Pueblo East Pit Adequacy Response #4

RE: Adequacy Review No. 4 Response, TR-06 Pueblo East Pit Permit M2000-041

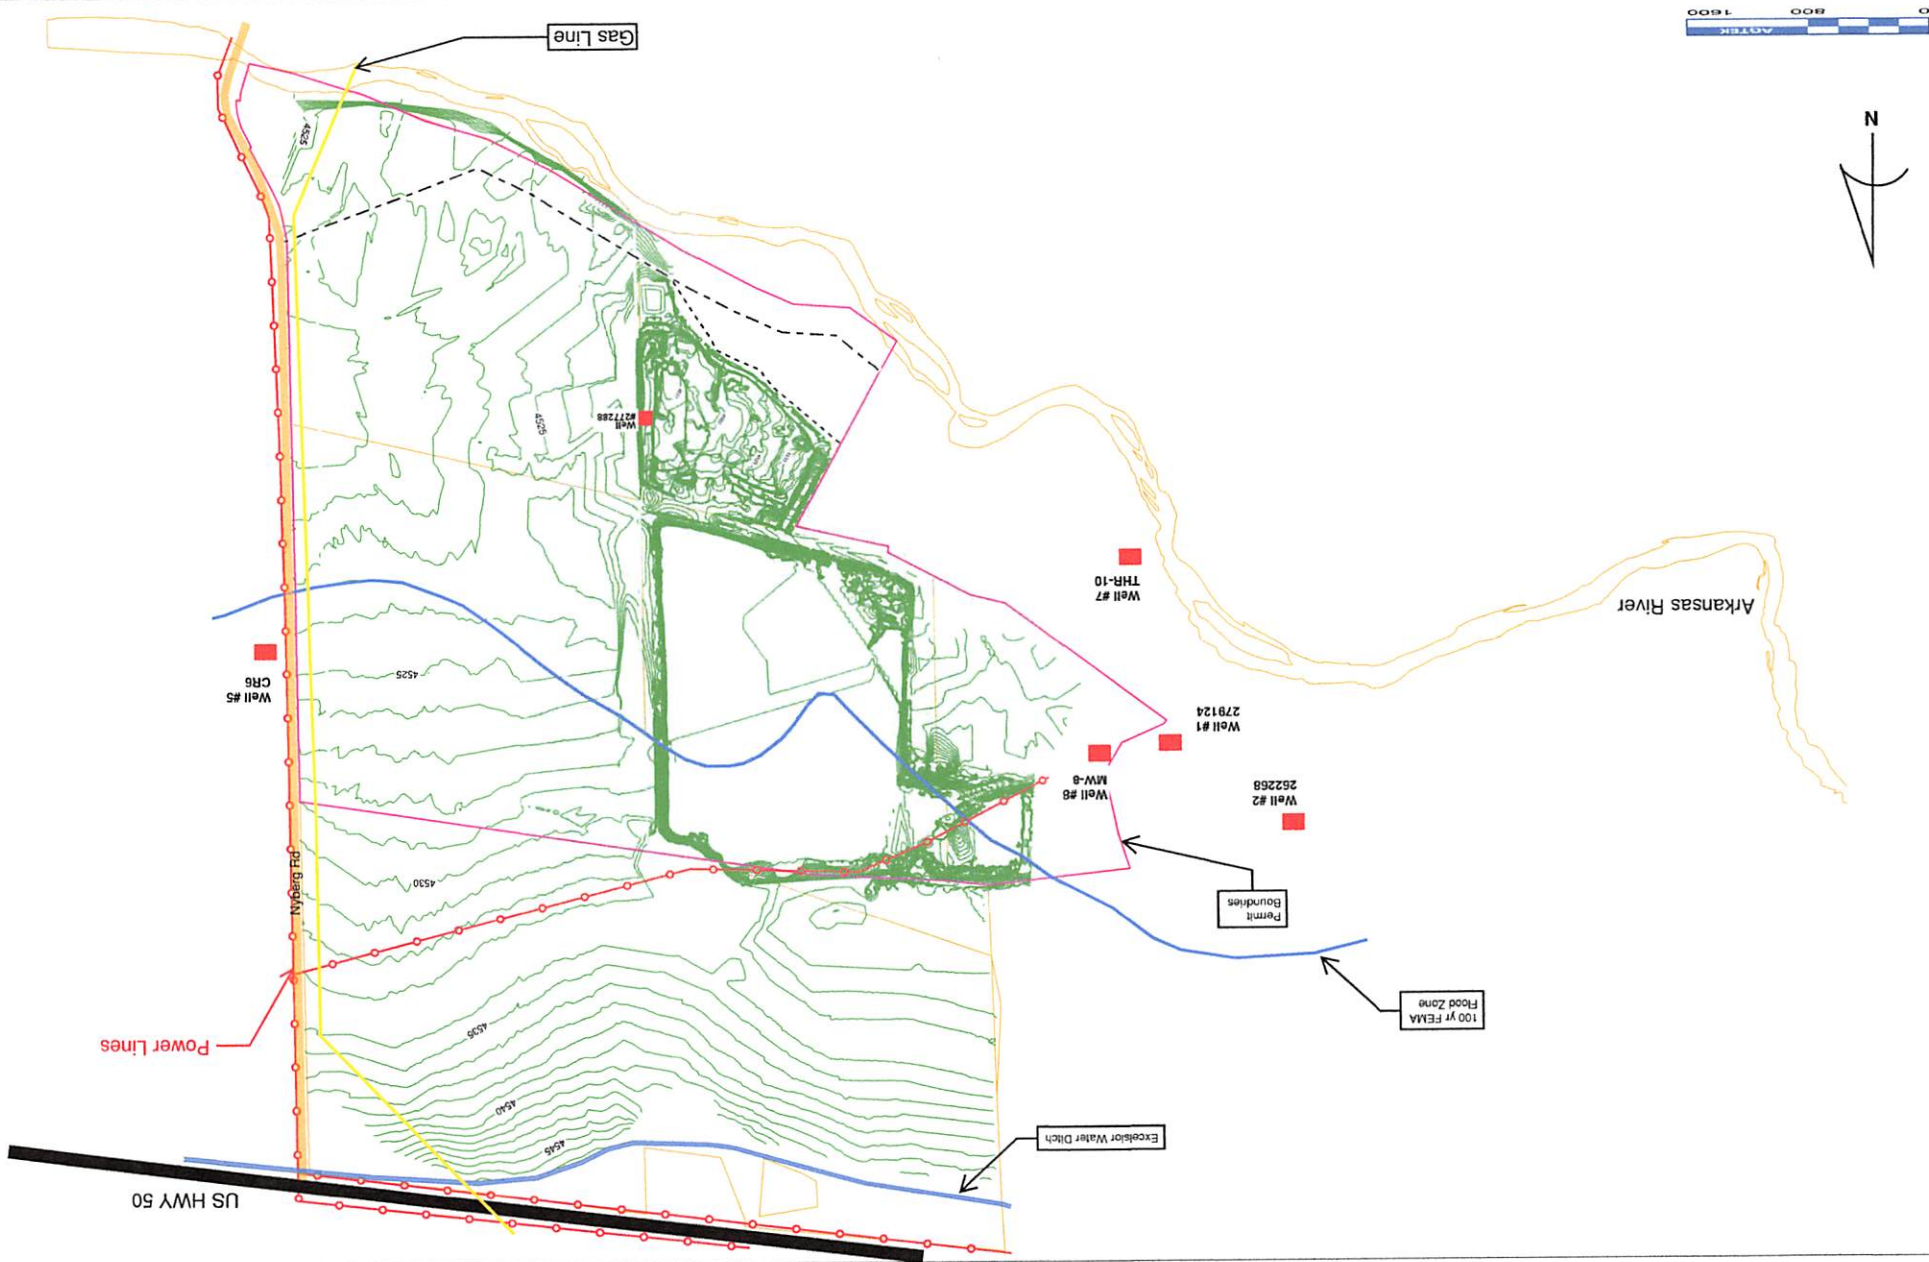
1. Attached is an Existing Conditions Map with the appropriate labels.
2. The Existing Conditions Map also includes Well ID Number 27728.
3. After further investigation, the well mentioned in the adequacy review has been removed.
Attached is the well abandonment report that was submitted to the Division of Water Resources on June 2, 2020.
4. The Reclamation Map has been updated to be consistent with the previous correspondence.
